SSD_7056: CAMPBELL'S STORES, THE ROCKS

MODIFICATION REPORT BAY 11

URBIS

Figure 1 – Comparison of approved (above) and modified (below) Bay 11 plant room

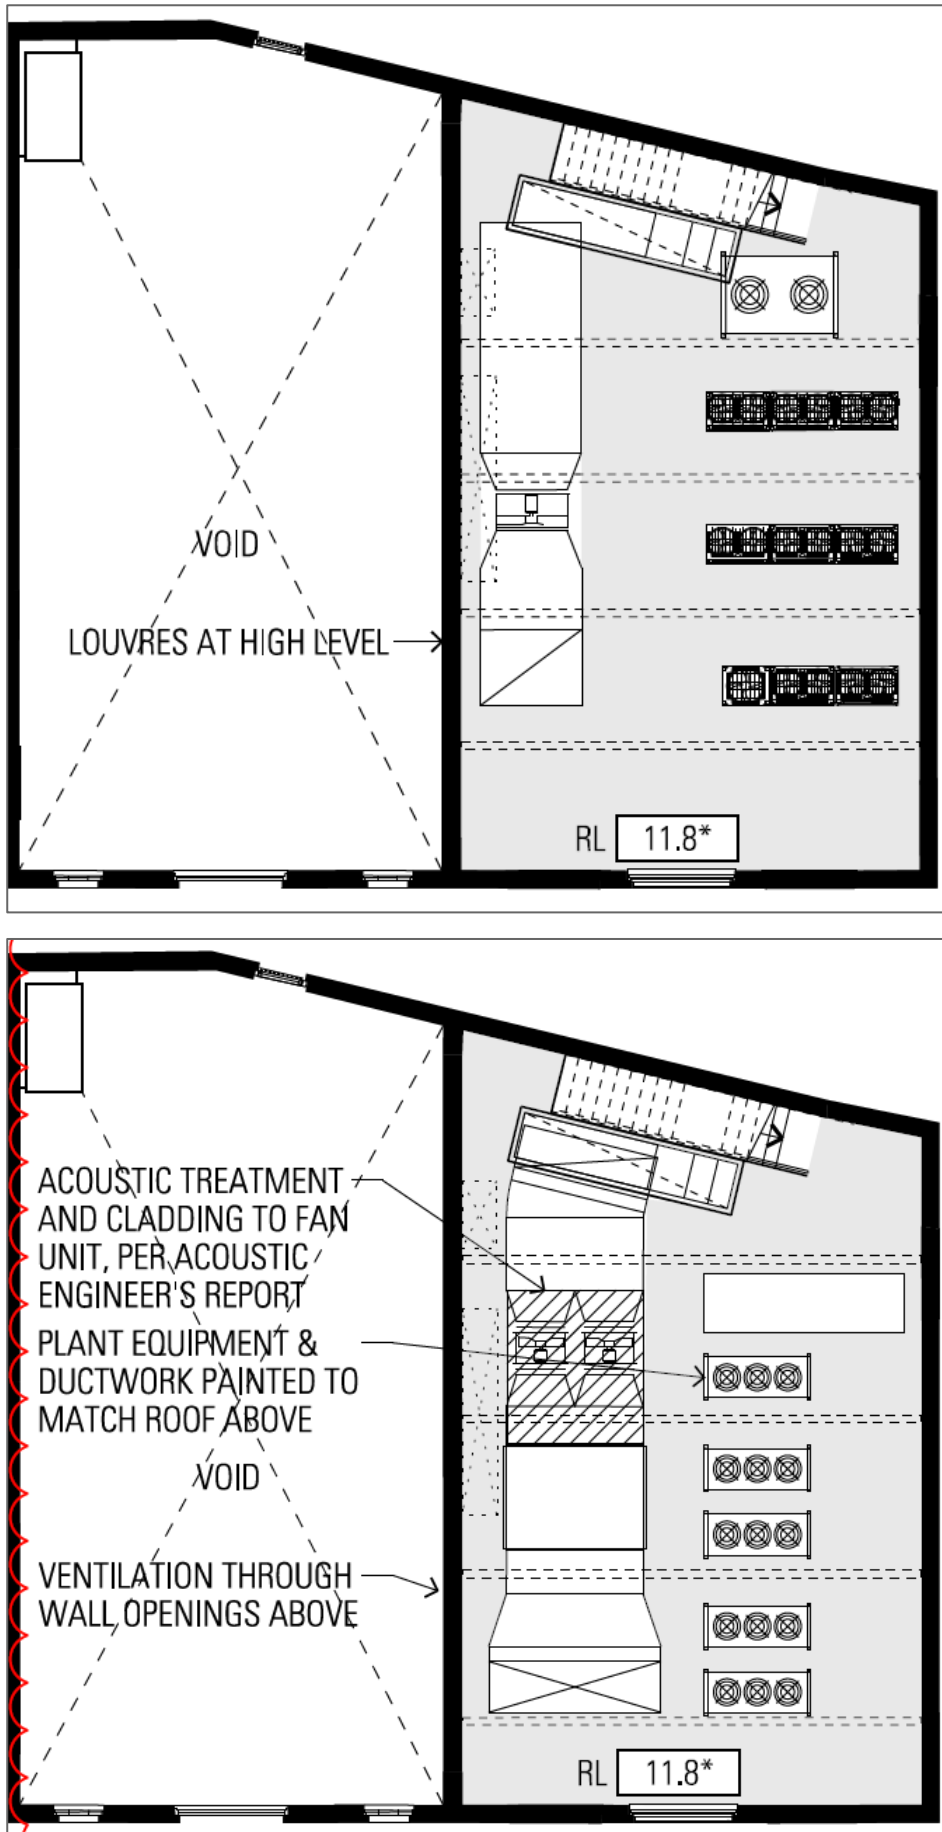
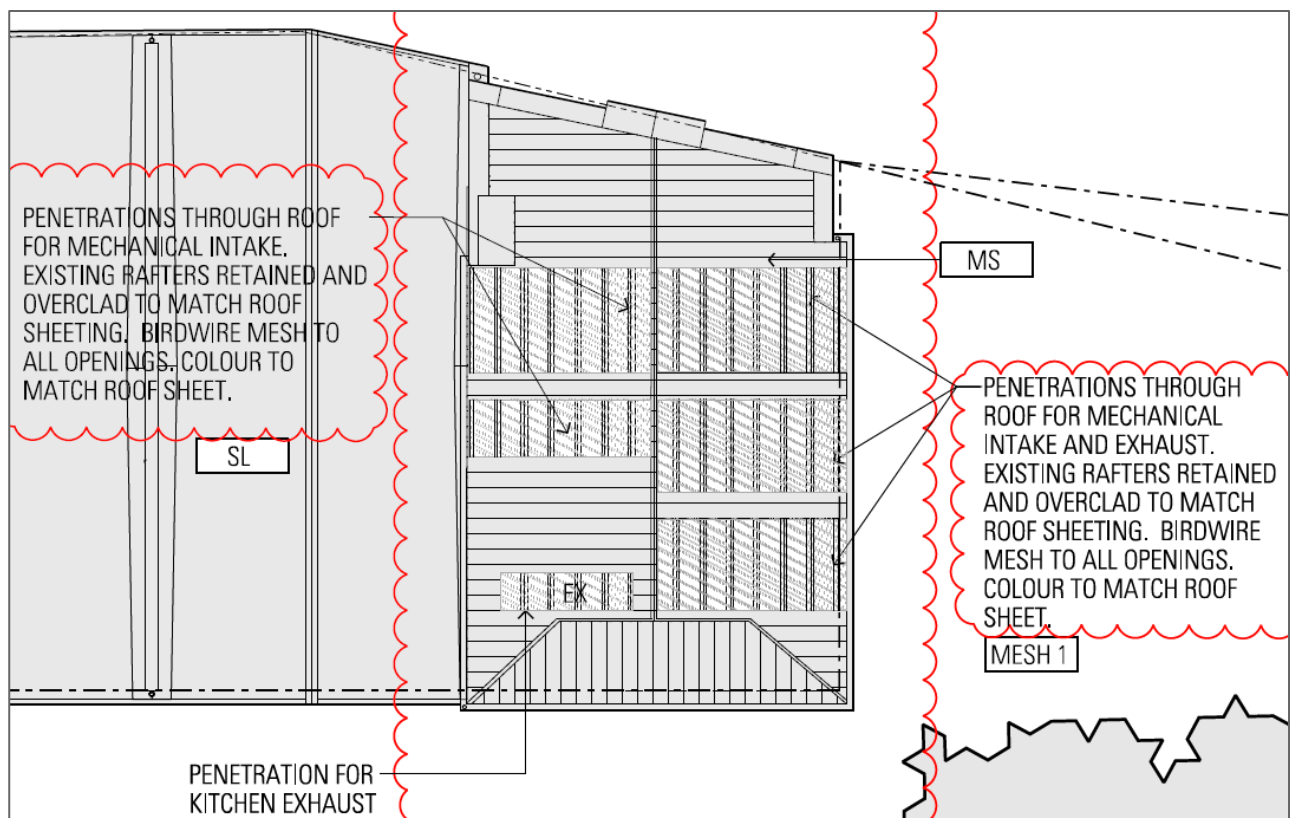
SSD_7056 provided approval for the removal of the existing mechanical exhaust system throughout Campbell's Stores and construction of a new centralised exhaust system within the roof of Bay 11, including penetrations in the roof structure to allow for natural ventilation of the plant room. During design development, mechanical engineers identified a need to amend the proposed mechanical ventilation system from an electrical generated system to a gas fired system due to the lack of sufficient electrical power at site.

The alternative gas fired system requires a minimum area of free air and therefore necessitates larger openings in the new Bay 11 roof sheeting, than was approved by SSD_7056. Consequently, this Modification seeks consent for alterations to the Bay 11 plant room and roof structure to allow for the refined mechanical ventilation system.

- The current approved design accommodates mechanical equipment within the roof space of Bay 11.
- The current approval has air intake and exhausts via openings in the new roof cladding of Bay 11.
- The roof cladding is not original fabric and is an approved replacement.
- The use of a gas fired system necessitates larger openings in the new roof sheeting, requiring a minimum area of free air.
- In order to minimise the visual impact of the larger openings, a fine mesh is proposed to cover the openings, the colour of which is to match the roof sheeting.
- All equipment and roof structures within the roof space are to be painted a recessive colour, to match the roof sheeting colour of Bay 11.

A comparison of the approved and modified Bay 11 plant room and roof is provided at Figure 1 and Figure 2 respectively.

Figure 3 – Comparison of approved (above) and modified (below) loading dock wall

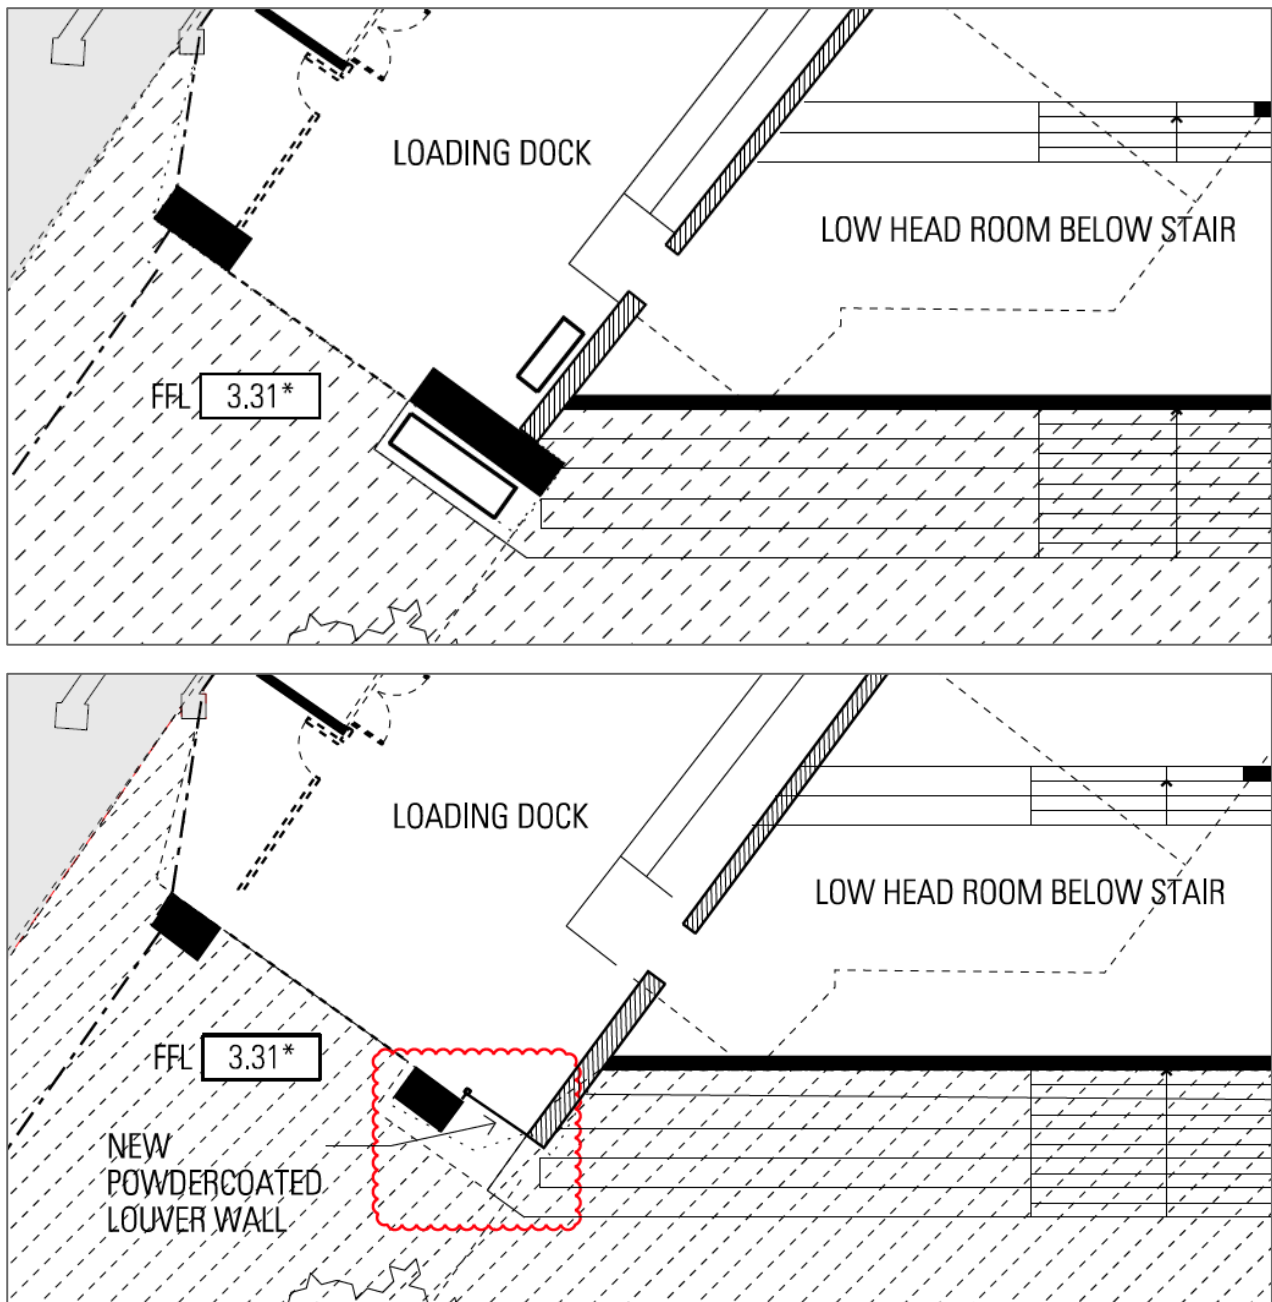
A new powder-coated louver wall has been added to the loading dock adjacent to Bay X stair to allow for improved mechanical ventilation. A comparison of the approved and modified loading dock wall is provided at Figure 3.

Figure 4 – Comparison of approved (left) and modified (right) toilet layouts at Ground Level Bay 6

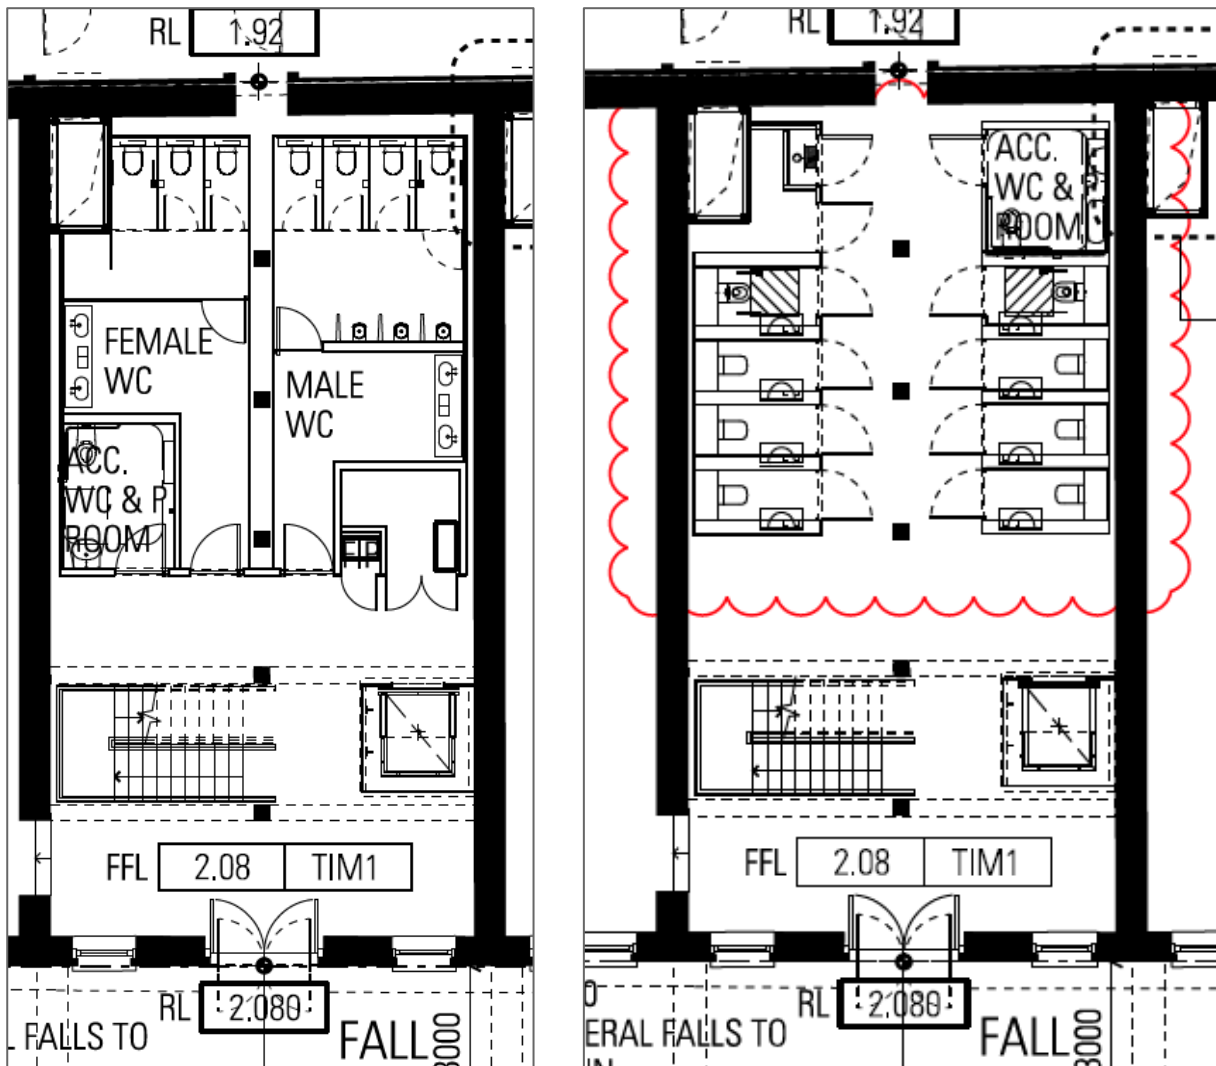
The toilet layout within Bay 6 at Ground Level has been refined and simplified during design development. The total number of toilets have not changed, including provision for accessible toilet facilities. A comparison of the approved and modified toilet layouts is provided at Figure 4.

Figure 5 – Proposed Bay 6 air vent within eastern eave

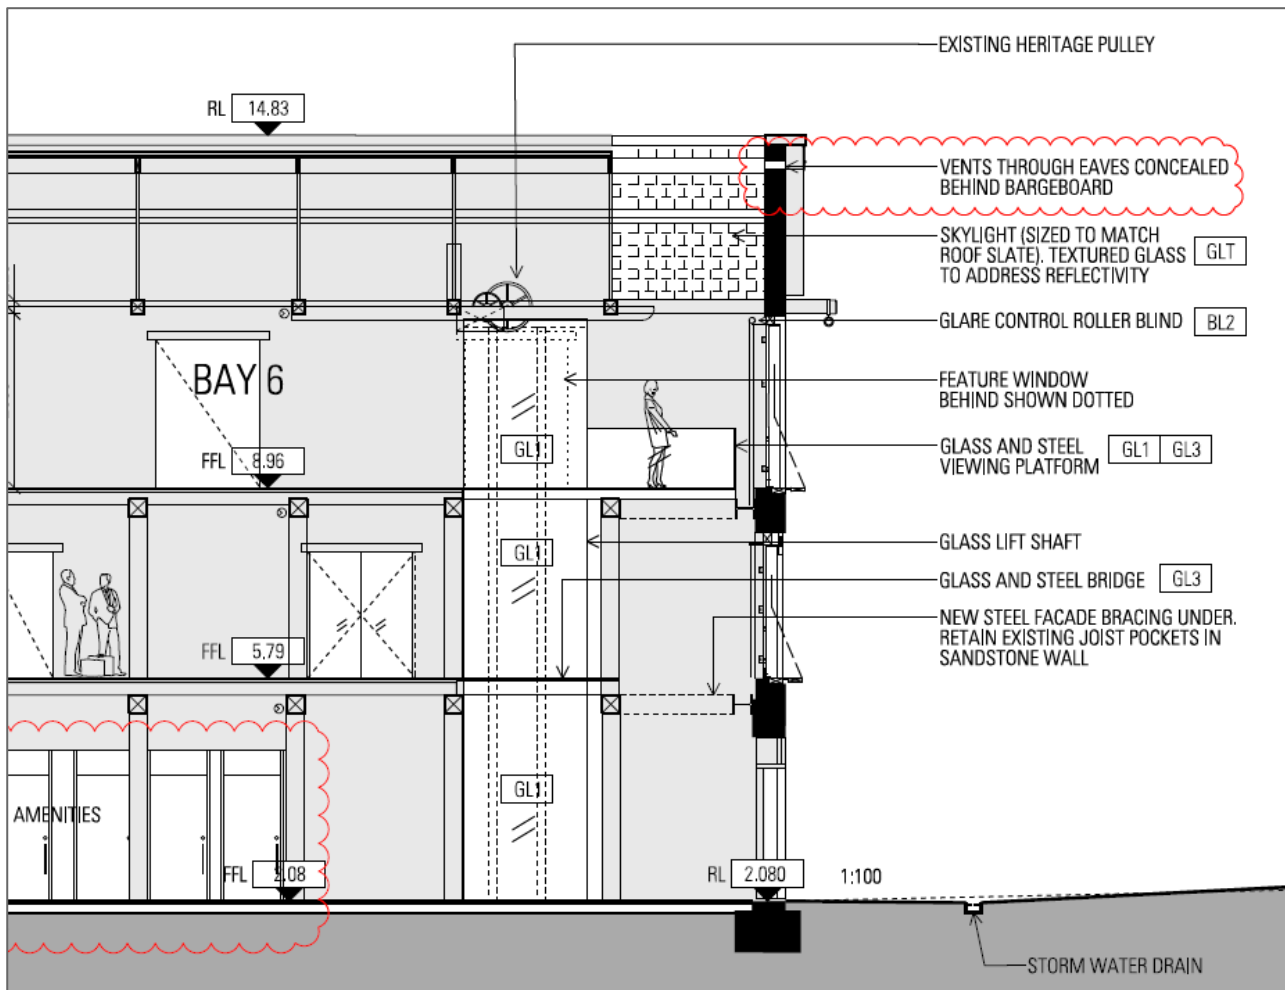
To prevent hot air build up below the skylight within the Bay 6 roof, it is proposed to provide two small air vents hidden behind the eaves on the eastern side of the building (refer Figure 5). This is similar to what is already approved in Bays 3 and 9 for the toilet exhaust.
